APPEAL APPLICATION

Case No. DIR-2017-2942-DRB-SPP; CEQA: ENV-2017-2943-CE

1099 Westwood Boulevard; Los Angeles, CA 90024

Applicant: Artisanal Brewers Collective, LLC (dba Broxton)

REMOUSED DOOR + AMERED DOOR! WIN OOW FRAME DAMASA TD WINDOW EXUIDIT

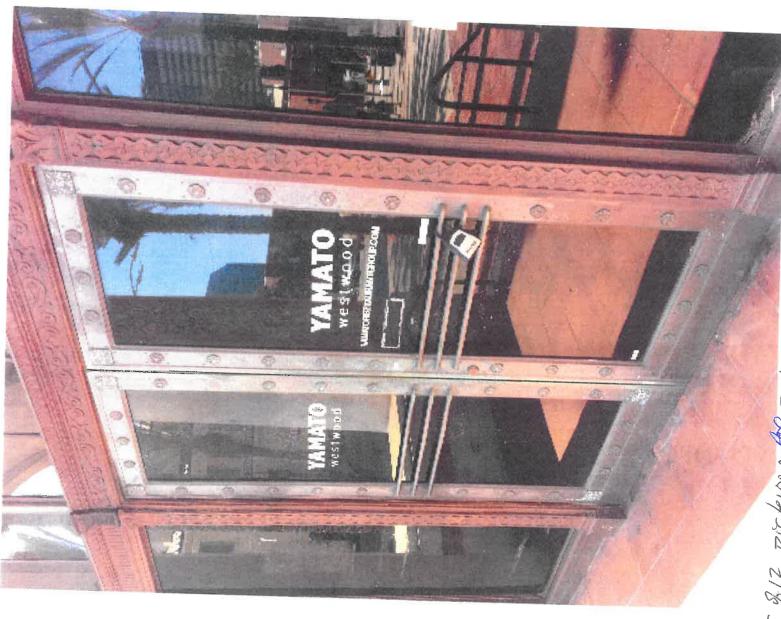
Please see the attached photos of one of the metal doors, door frames, window frames, and at least one window (lower left pane) facing Westwood Boulevard that have been removed and altered.

Based on these facts, and especially the illegal removal of the door and damage to some of the existing window panes, I believe your Commission must grant this appeal.

HISTORIC PHOTO SHOWING ORGANIZ MULTI-PANES WHUDOW

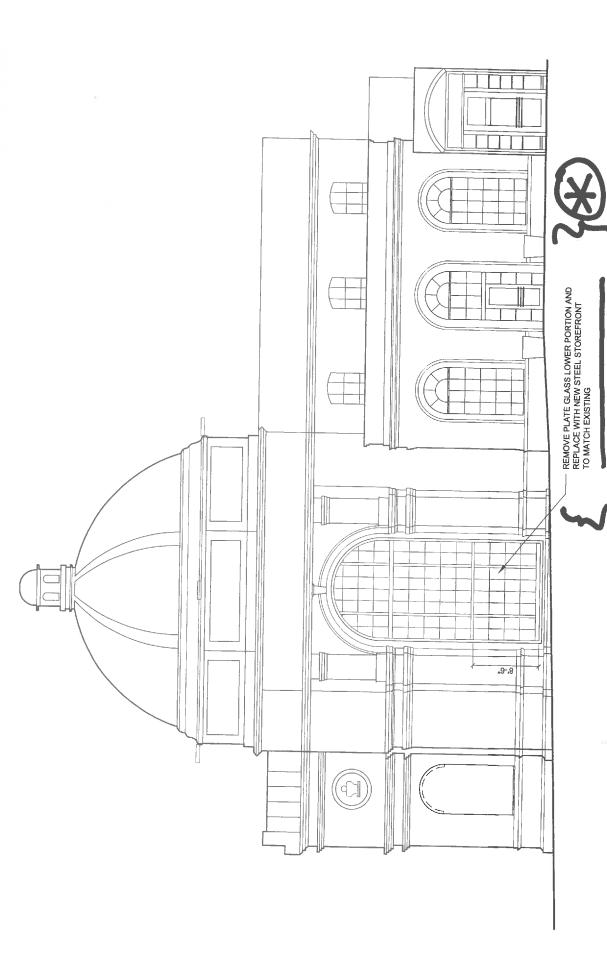
However, on BOTH sets of plans by the two different architects, the Applicant submitted plans to the Westwood Neighborhood Council showing their intention to repair and restore the partially altered and destroyed lower portion of one of the monumentally scaled arched windows contained in the Domed portion of the Rotunda, facing Westwood Boulevard.

EAST ELEVATION

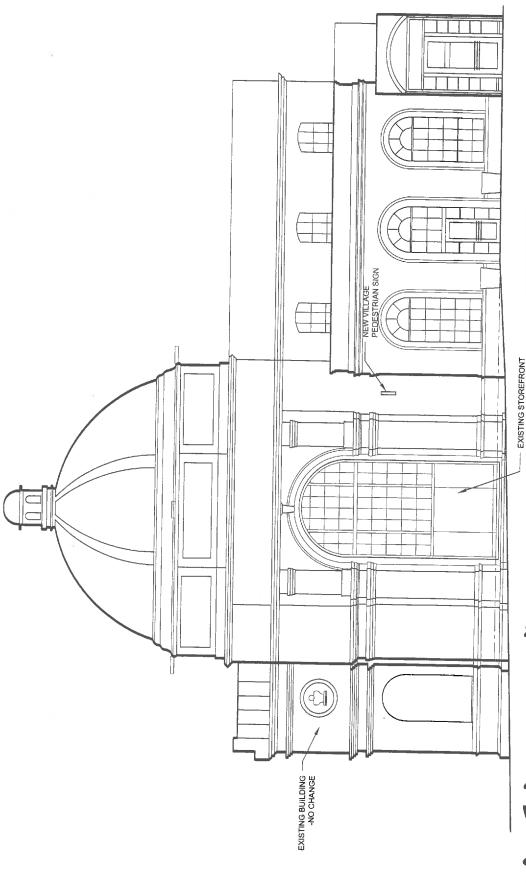
In fact, on Sheet 15 ("East Elevation") in the Plans drawn by Anthony Eckelberry architect, which Plans were most recently submitted by the Applicant's representative, Margaret Taylor, to the Westwood Neighborhood Council, these Plans include the following Note (written in ALL CAPS):

"REMOVE PLATE GLASS LOWER PORTION AND REPLACE WITH NEW STEEL STOREFRONT TO MATCH EXISTING".

Said new steel multi-paned windows will essentially match the drawing of said plate glass section on Page 15 of the set of plans Applicant initially brought to the WWNC early in 2017 and not the drawing on Page 15 of the set of Plans filed with the DRB this past summer.

"BATT & SWITCH"

BE IT RESOLVED, THAT the Westwood Neighborhood Council wants Artisanal Brewers Collective, LLC. (ABC), Applicant, to submit a repair and restoration plan for project review and approval by the Westwood Community Design Review Board (DRB), and to obtain a Certificate of Appropriateness (COA) from the Director of Planning upon recommendation by the Westwood DRB, that removes the damaged lower portion of the original monumental and multi-paned arched window in the main portion of the Janss Dome Building facing Westwood Boulevard, and replaces this altered plate glass section with new steel multi-paned windows to match the original design that conforms with the Westwood Village Specific Plan's provisions, the Secretary of the Interior's Standards for Rehabilitation, and the City of Los Angeles Office of Historic Preservation requirements.
